**ADDENDUM FOR
TENDER NO: MOICT/SDICT/ONT/017/2021-2022**

**TENDER FOR SUPPLY, INSTALLATION AND COMMISSIONING OF
NETWORK INFRASTRUCTURE
AT NYAMIRA LEVEL IV COUNTY HOSPITAL, NYAMIRA COUNTY**

ISSUE DATE: 23RD AUGUST, 2021

NYAMIRA COUNTY REFERRAL HOSPITAL
 ADMIN/BLOCK 1
 PROPOSED NETWORK LAYOUT

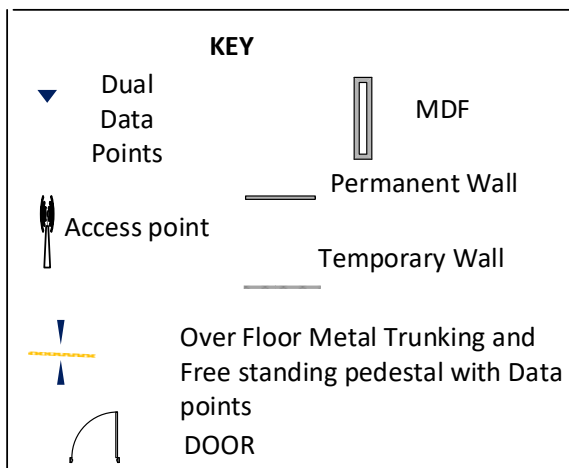
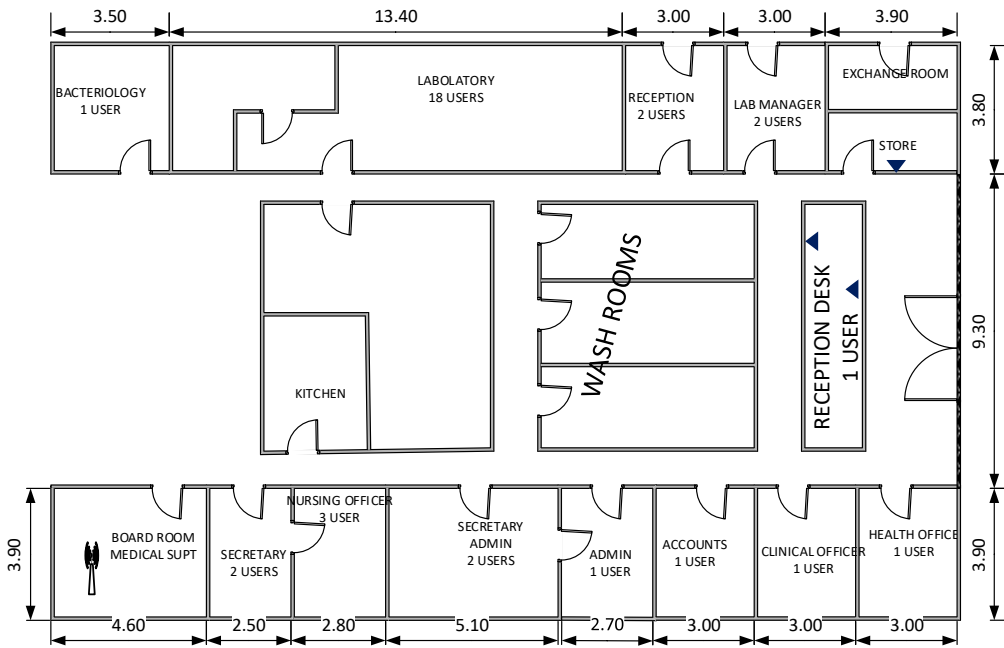
3.	<p>The following blocks have existing LAN:</p> <ul style="list-style-type: none"> a. Administration Block 1 	<p>There will be no new installation of the structured cabling Network in these Blocks but ports will be repaired and added where necessary.</p> <p>Optic Fiber cable shall be pulled to integrate with the new network</p> <p>The Bill of Materials, Price Schedule and network designs drawings have been amended to accordingly to reflect the new requirements as specified in section 3.0, 4.0 and 5.0 of this Addendum.</p>

**Existing LAN
 Add 6 Data Points**

**NYAMIRA COUNTY REFERRAL HOSPITAL
GROUND FLOOR BLOCK 2
PROPOSED NETWORK LAYOUT**

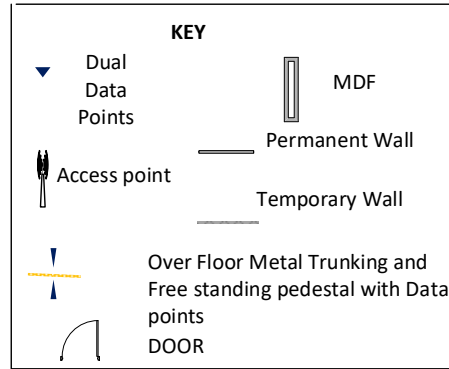
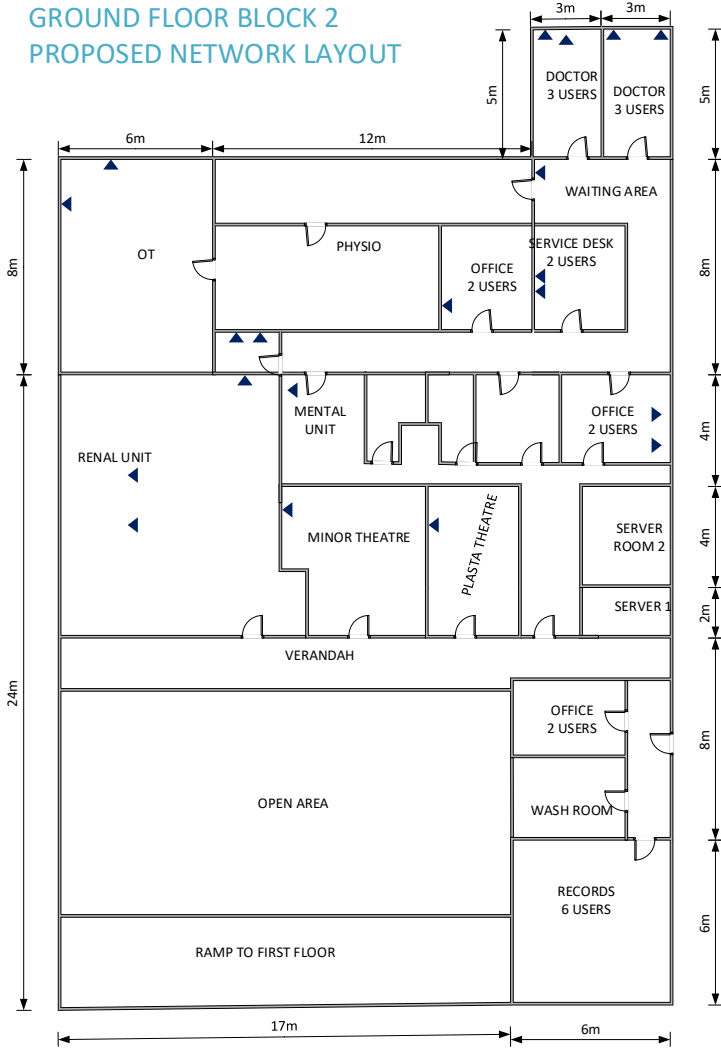
No.	ISSUES THAT CAME UP	CLARIFICATION
1.	<p>The following blocks were reorganized and new service points added:</p> <ul style="list-style-type: none"> a. Ground Floor Block 2 b. Paedriatic ward c. Female ward d. Ground Floor Block 3 	<p>The Bill of Materials, Price Schedule and network designs drawings have been amended to accordingly to reflect the new requirements as specified in section 3.0, 4.0 and 5.0 of this Addendum</p>

**Existing LAN
Add 36 Data Points**

**NYAMIRA COUNTY REFERRAL HOSPITAL
GROUND FLOOR BLOCK 3
PROPOSED NETWORK LAYOUT**

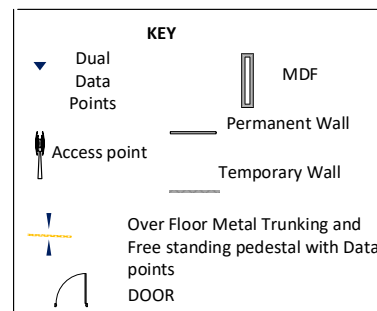
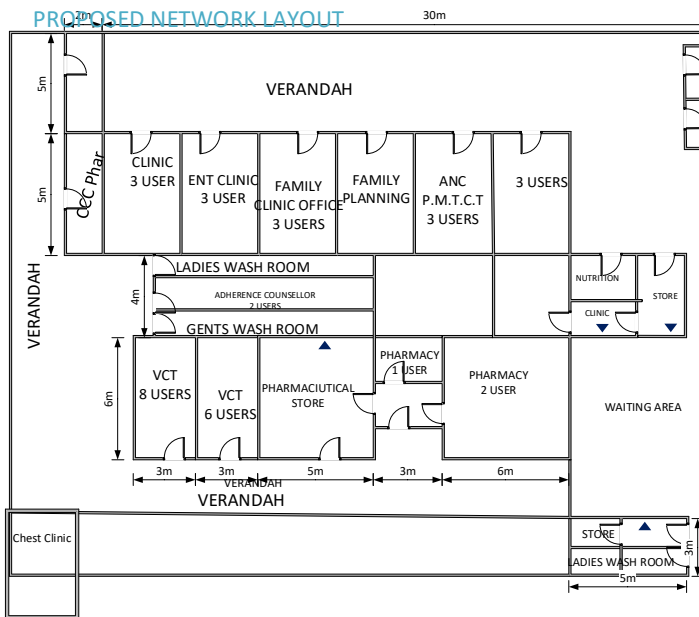
**Existing LAN
Add 18 Data Points**

NYAMIRA COUNTY REFERRAL HOSPITAL
 MAINTENANCE WORKSHOP
 PROPOSED NETWORK LAYOUT

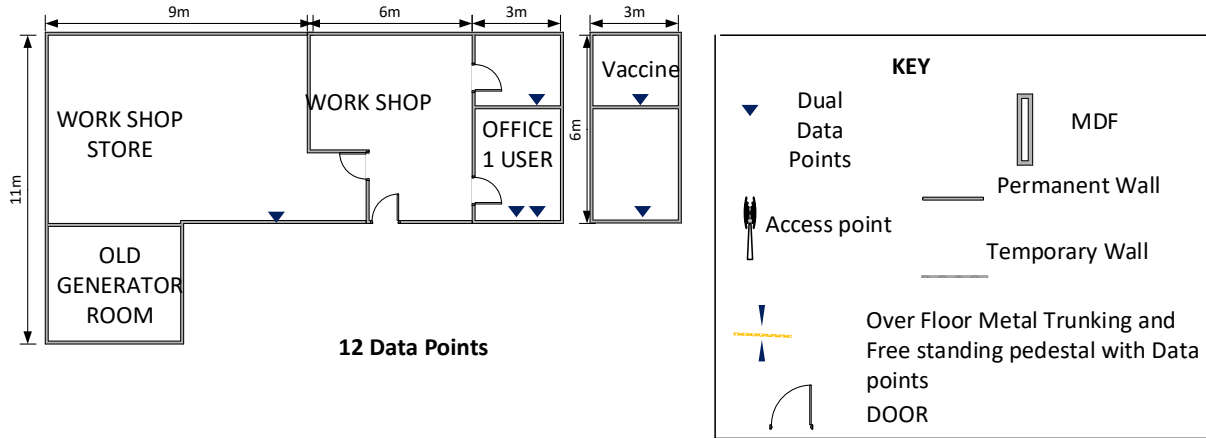
2.	<p>The following blocks did not have data points indicated in the drawings:</p> <ul style="list-style-type: none"> a. Maintenance b. RDF c. Maternity 	<p>The Bill of Materials, Price Schedule and network designs drawings have been amended to accordingly to reflect the new requirements as specified in section 3.0, 4.0 and 5.0 of this Addendum.</p>

NYAMIRA COUNTY REFERRAL HOSPITAL
MATERNITY WARD
PROPOSED NETWORK LAYOUT

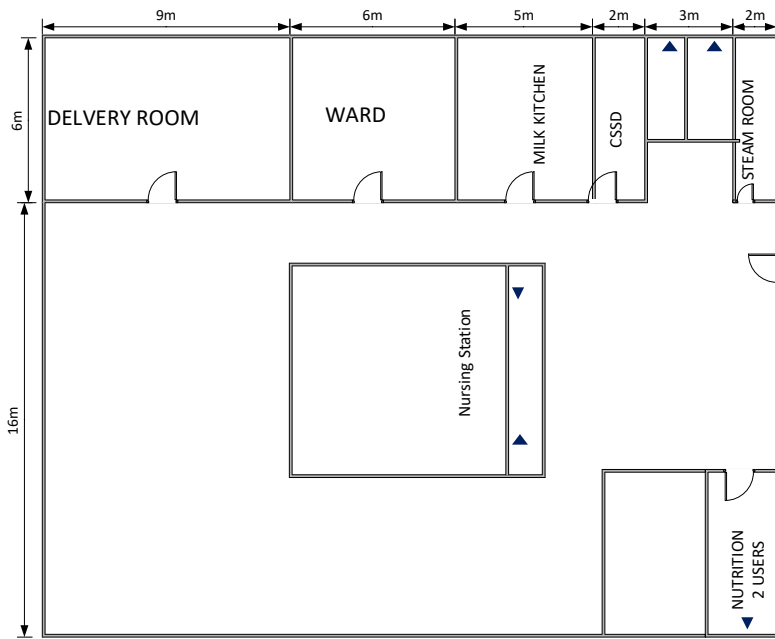
10 Data Points

NYAMIRA COUNTY REFERRAL HOSPITAL
ICU
PROPOSED NETWORK LAYOUT

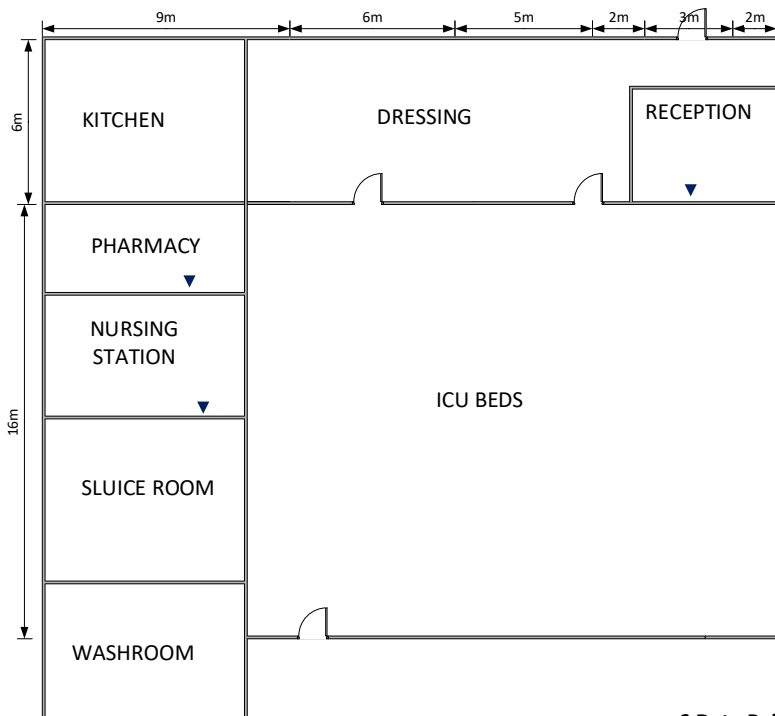
4.	<p>The drawings of the following Blocks were missing from the Tender Document:</p> <ul style="list-style-type: none"> a. Laundry/ Procurement/Kitchen/ Non-Pharmaceuticals stores b. Gate c. Theatre d. ICU 	<p>The Bill of Materials, Price Schedule and network designs drawings have been amended to accordingly to reflect the new requirements as specified in section 3.0, 4.0 and 5.0 of this Addendum.</p>

6 Data Points

NYAMIRA COUNTY REFERRAL HOSPITAL
THEATRE
PROPOSED NETWORK LAYOUT

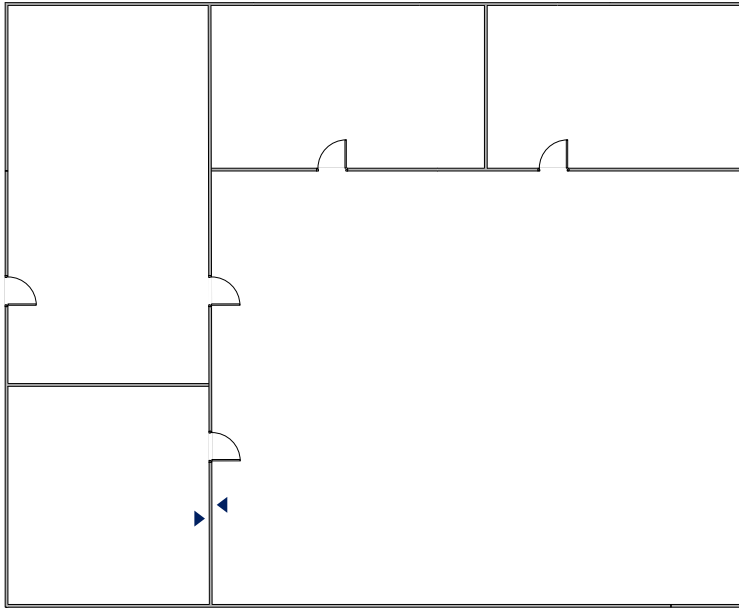
4 Data Points

NYAMIRA COUNTY REFERRAL HOSPITAL
 PAEDRITIC WARD
 PROPOSED NETWORK LAYOUT

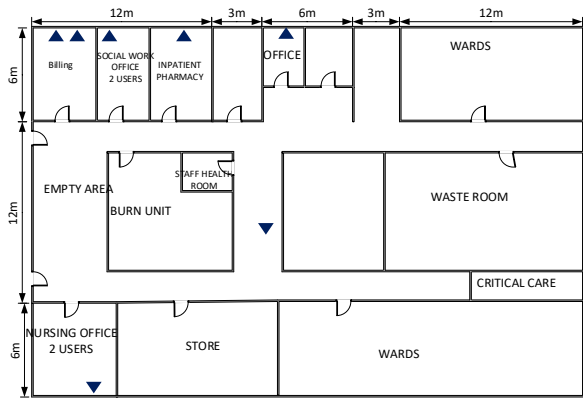
14 Data Points

NYAMIRA COUNTY REFERRAL HOSPITAL
 CT-SCAN
 PROPOSED NETWORK LAYOUT

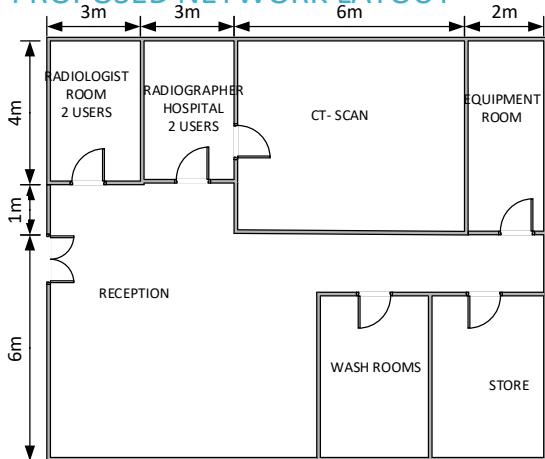
5.	<p>There exists a network serving the CT-Scan, Radiology. The existing active devices are not POE & some have reached end of life.</p>	<p>The Bill of Materials and Price Schedule have been amended to accordingly to reflect the new requirements as specified in section 3.0 and 4.0 of this Addendum.</p> <p>Optic Fiber cable shall be pulled to integrate with the new network</p>

**Existing LAN
 Link to the Aggregation Switch**

NYAMIRA COUNTY REFERRAL HOSPITAL
RADIOLOGY
PROPOSED NETWORK LAYOUT

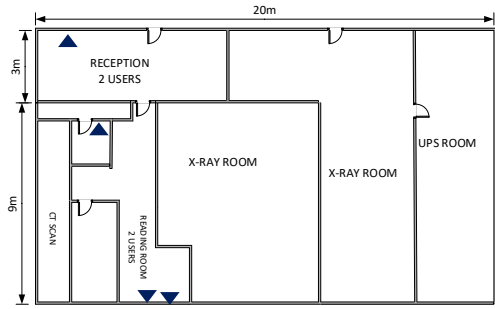
Existing LAN
Add 8 Data Points

NYAMIRACOUNTY REFERRAL HOSPITAL
FEMALE/MALE WARD
PROPOSED NETWORK LAYOUT

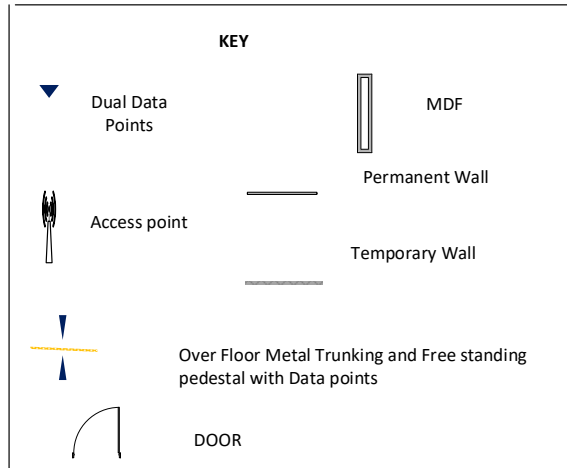
16 Data Points
